STAFF REPORT
COMMUNITY DEVELOPMENT DEPARTMENT

SUBJECT: H-2021-0080
 Verona Live/Work – CUP

I. PROJECT DESCRIPTION

Conditional Use Permit for 16 vertically integrated residential units within four (4) buildings on 1.75 acres in the L-O zoning district.

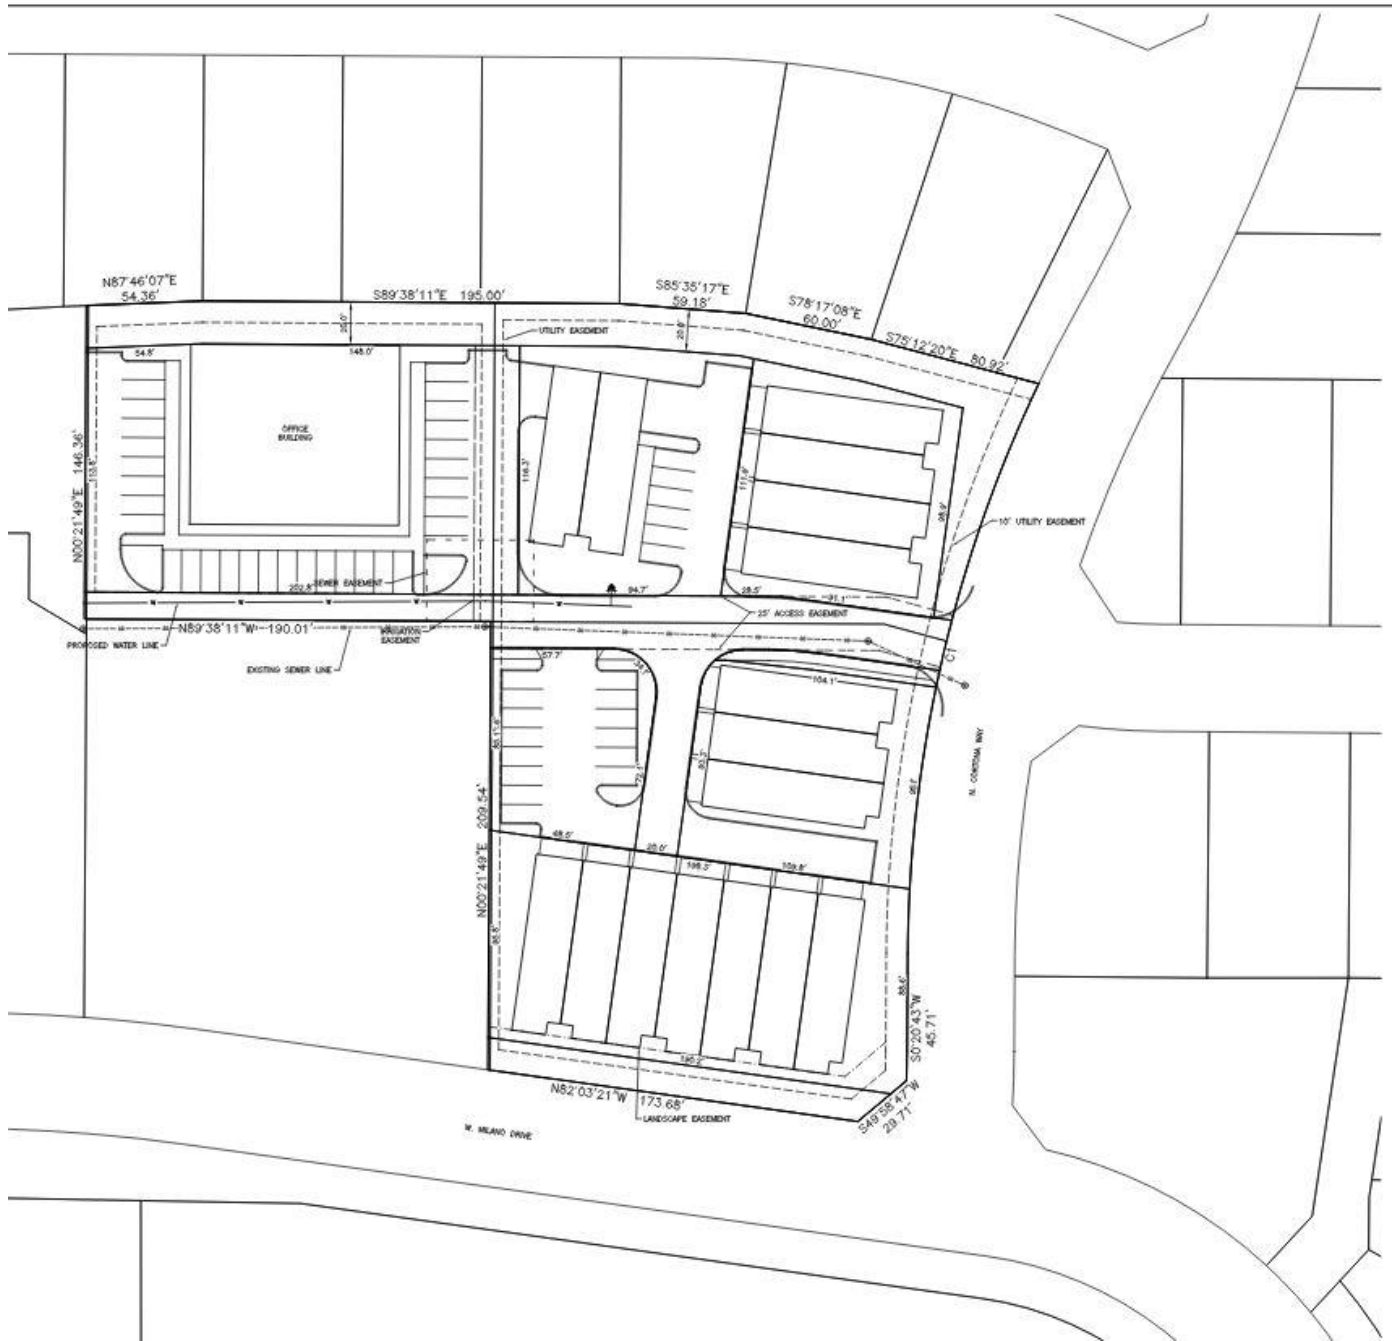
The submitted plans do not show any additional sidewalk connections from the front of the buildings to the existing sidewalks, as required in UDC 11-3A-19. Staff finds this to be a missed opportunity to activate the building frontage with the adjacent streets for the commercial suites. Therefore, consistent with Staff's additional recommendations to add a separate commercial door on the front façade of each unit, Staff is recommending additional 5-foot wide sidewalks are constructed from the front of the units facing public streets (14 of the 16 units). Because of the overall design of the units abutting each other in a mirrored format, Staff is acceptable to shared connections to the attached sidewalks so long as each unit entrance has a sidewalk connection to the shared connection. Please see exhibit below for an example:

- b. For the facades facing W. Milano Drive and N. Cortona Way, depict additional 5-foot wide sidewalks connecting from these building entrances to the existing sidewalks along the public streets.

A. Site Plan (date: 10/6/2021) **(NOT APPROVED)**

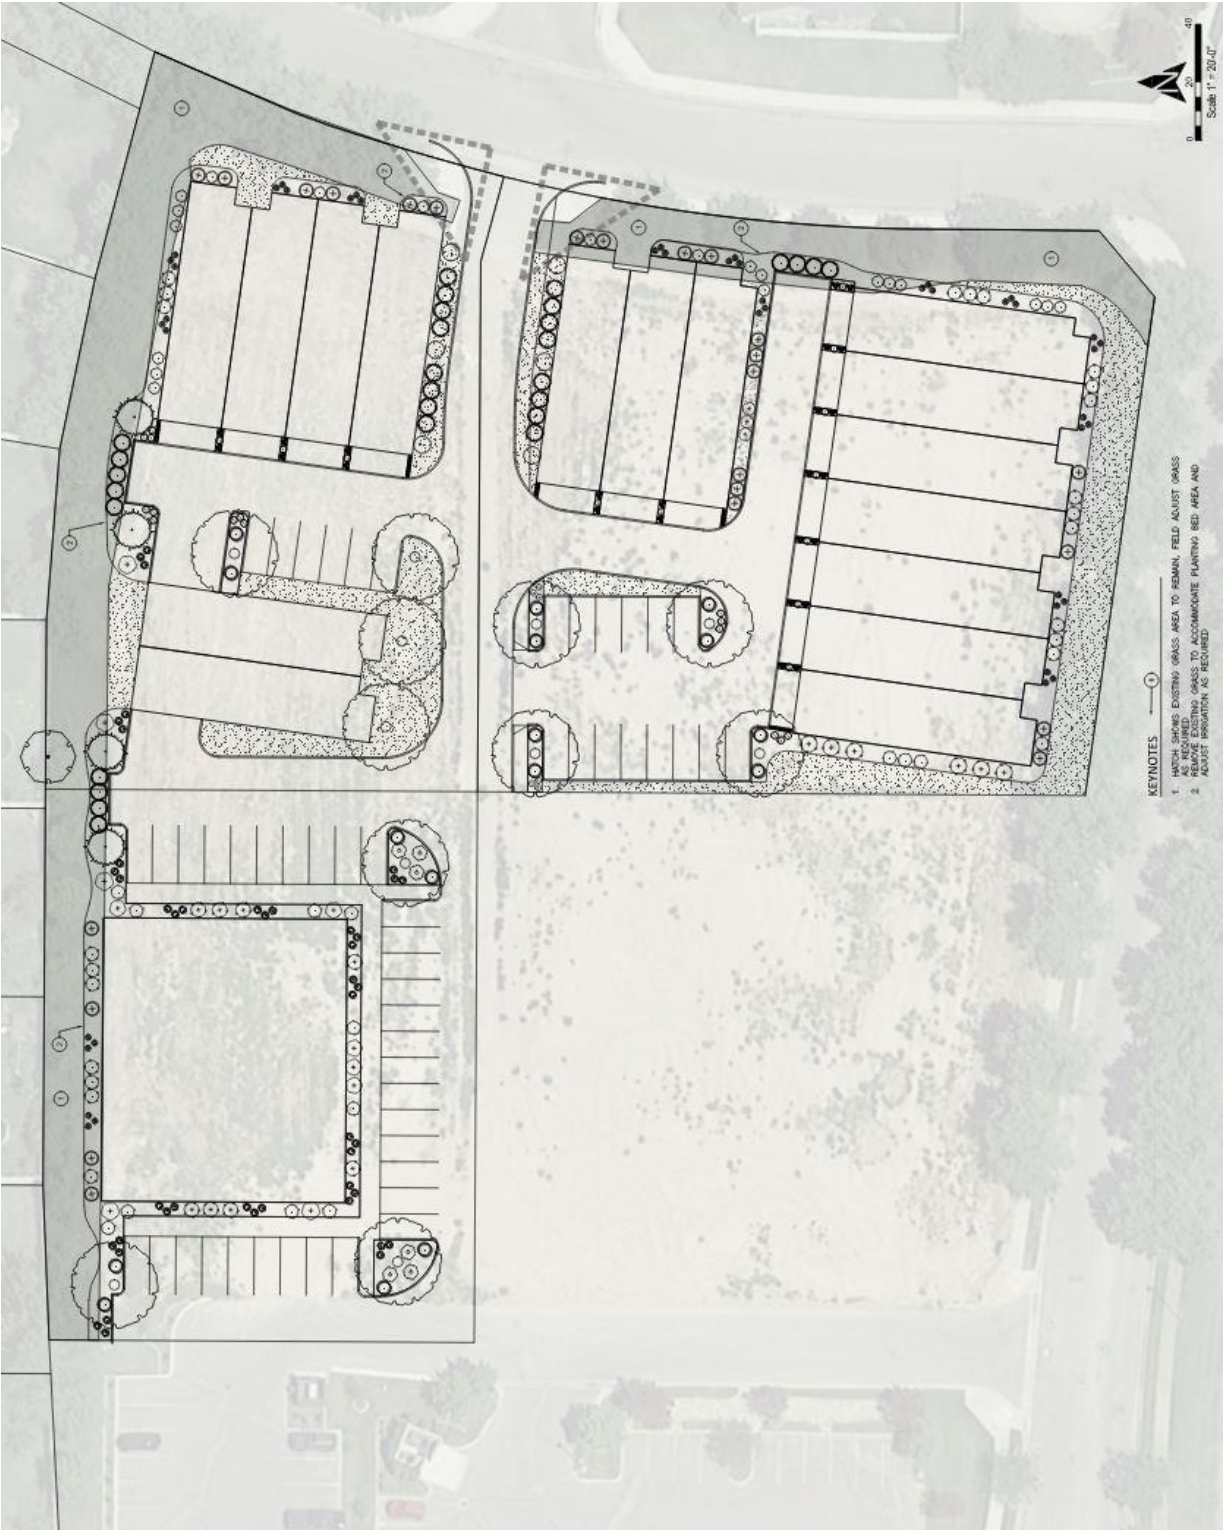
The submitted site plan shows the drive aisles adjacent to the garages as 20 feet wide which does not comply with UDC 11-3C-5 standards for two-way drive aisles. A two-way drive aisle, applicable throughout the site, requires a minimum width of 25 feet. The Applicant should revise the plans to show compliance with this standard at the time of Certificate of Zoning Compliance (CZC) submittal.

One (1) driveway access is depicted on the overall site plan and connects to N. Cortona Way along the east boundary of the site – the only direct access to a public street for the project. The submitted plans also show the main drive aisle that bisects the project and lies across the shared property line to continue west to connect to an existing drive aisle utilized for the two office buildings along Ten Mile – this drive aisle connects to W. Milano Drive approximately 190 feet west of the subject sites. The additional office building shown on the submitted site plan is not part of this project and would likely only require administrative applications in order to be constructed.

The site plan shows multiple drive aisles off of the main east-west drive aisle for access to the proposed vertically integrated units and the two-car garages. Staff anticipates the two access points shown on the site plans would be needed for safest and most efficient flow of traffic for this proposed project despite the future office building to the west not being a part of this project. Because of this, Staff is recommending a condition of approval to construct the northern portion of this drive aisle with this project to ensure adequate traffic flow for the site regardless of the timing of development of the office site shown west of the subject sites.

5. The site plan(s) shall be revised as follows prior to the Planning and Zoning Commission hearing:
 - a. All drive aisles shall be a minimum of 25 feet wide, per UDC 11-3C-5 standards.

- c. Remove the two units framing the corner of W. Milano Drive and N. Cortona and add a shared plaza space with outdoor seating and shade structures.

- d. Remove the two units not along the adjacent streets in lieu of additional parking and some usable common open space for the development.
6. The landscape plan(s) submitted with the Certificate of Zoning Compliance application shall depict the following revisions:

B. Landscape Plan (date: 9/30/2020)

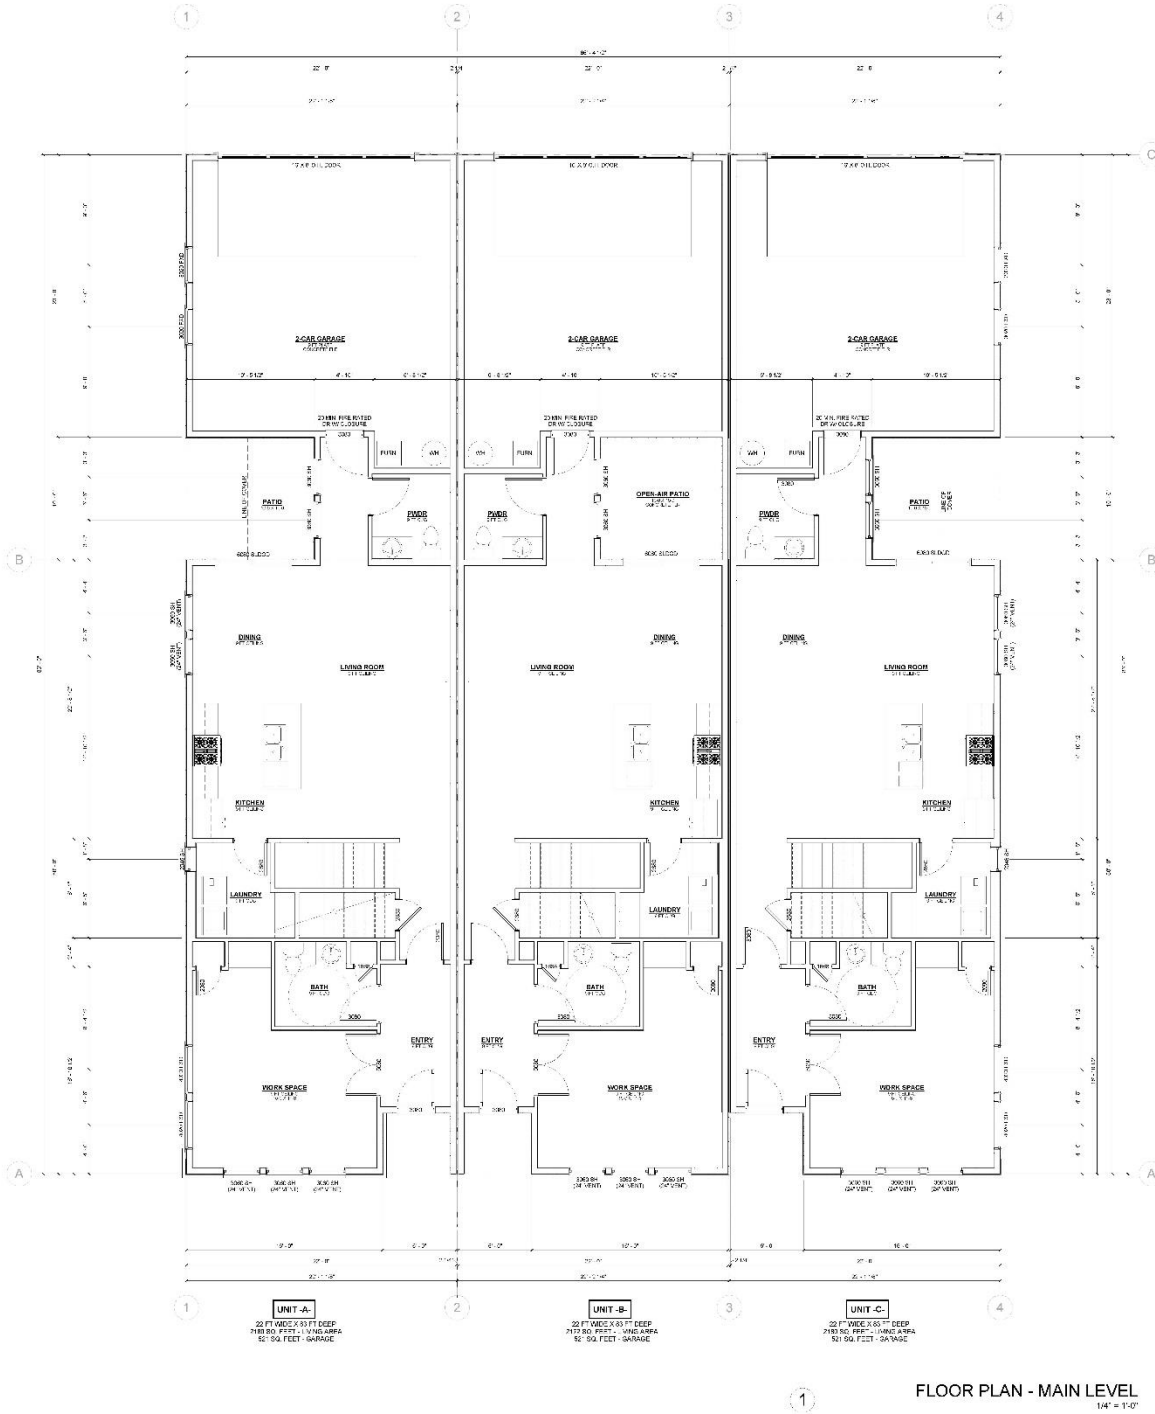
All required street buffers are existing and comply with code requirements. The submitted landscape plan depicts the required 20-foot wide use buffer along the north property boundary but does not show the required number of trees. According to the aerial imagery, there appears to be existing and mature trees in this buffer but this is not depicted on the plans. The existing landscape conditions should be added to the plans with the future CZC submittal.

The required parking lot landscaping appears to be compliance with UDC requirements except for the area adjacent to the parking lot along the west boundary on the south parcel. D. This should also be revised with the future CZC submittal.

According to the submitted landscape plan, it is unclear if any fencing is proposed with this project. Code does not require perimeter fencing but there is existing fencing along the north property boundary that belongs to those homes within the Verona Subdivision. If any additional fencing is proposed in the future, a detail of the proposed fencing should be included on the landscape plans with the CZC application that demonstrates compliance with the standards in UDC 11-3A-7.

- a. Depict all existing landscaping on the subject sites to ensure compliance with UDC standards.
 - b. Depict at least 5 feet of landscaping and the required number of trees along the west project boundary and adjacent to the proposed parking lot on the south parcel (3042 W. Milano Drive).

- c. Depict the additional 5-foot wide sidewalks as noted above.
 - d. Depict the shared plaza as noted above with appropriate landscaping elements.
7. The conceptual building elevations and renderings shall be revised as follows prior to the Planning and Zoning Commission hearing:

1 FLOOR PLAN - UPPER LEVEL
1/4" = 1' 0"

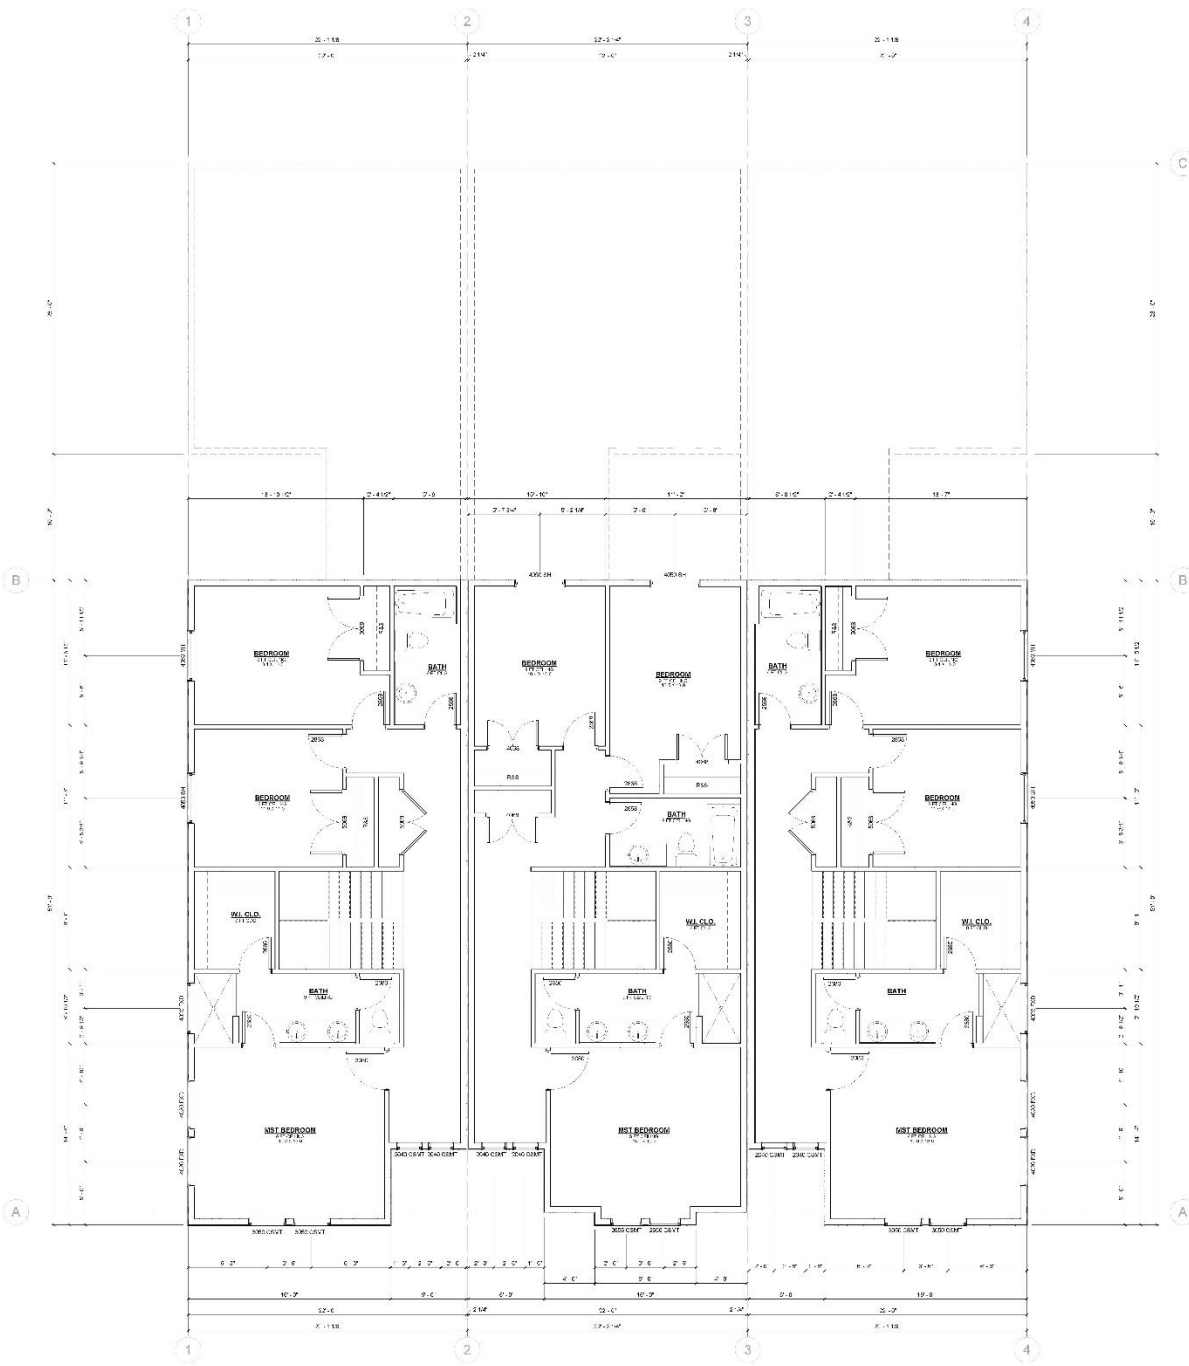
However, the proposed unit design is what creates concern and Staff finds it does not fully meet the noted definition of Vertically Integrated as currently proposed. The submitted floor plan shows a relatively small commercial suite that has minimal storage space for inventory, no separate room for meetings, and no outdoor patio space to help activate the commercial frontage. Staff is concerned this small space could be rented out as a separate residential unit without the City being the wiser OR would become an office for the residence and not serve the nearby neighborhood as intended with the commercial component of vertically integrated residential projects. The proposed size of the commercial spaces in each unit will likely not support many of the allowed uses noted in the specific use standards for this use. This furthers Staff's concern that these units may become standalone residential, which is not an allowed use in the L-O zoning district.

In order to help with some of the concerns noted, Staff is recommending the following revisions to the plans: 1) expand the commercial area of the units to potentially encompass the entire first level; 2) remove the first exterior door to help delineate the commercial and residential areas of the units by creating two exterior facing doors; one for the residential, and one for the commercial suite; and 3) remove the two (2) units that frame the hard corner of W. Milano Drive and N. Cortona Way to incorporate a shared plaza space similar to what exists in the commercial area on the south side of McMillan in Bridgetower Crossing. With the addition of outdoor patio space/shared patio space the commercial component of this development would help activate some of the commercial spaces. Additional and more specific recommendations can be found under the elevation analysis below and in the conditions of approval in Section X.A.

8. Prior to the Planning and Zoning Commission hearing, the conceptual floor plans shall be revised as follows:
 - a. Expand the commercial areas of at least some of the units to help the viability of the commercial component of this project.

- b. Remove the first exterior door to help delineate the commercial and residential areas of the units by creating two exterior facing doors; one for the residential, and one for the commercial suite.
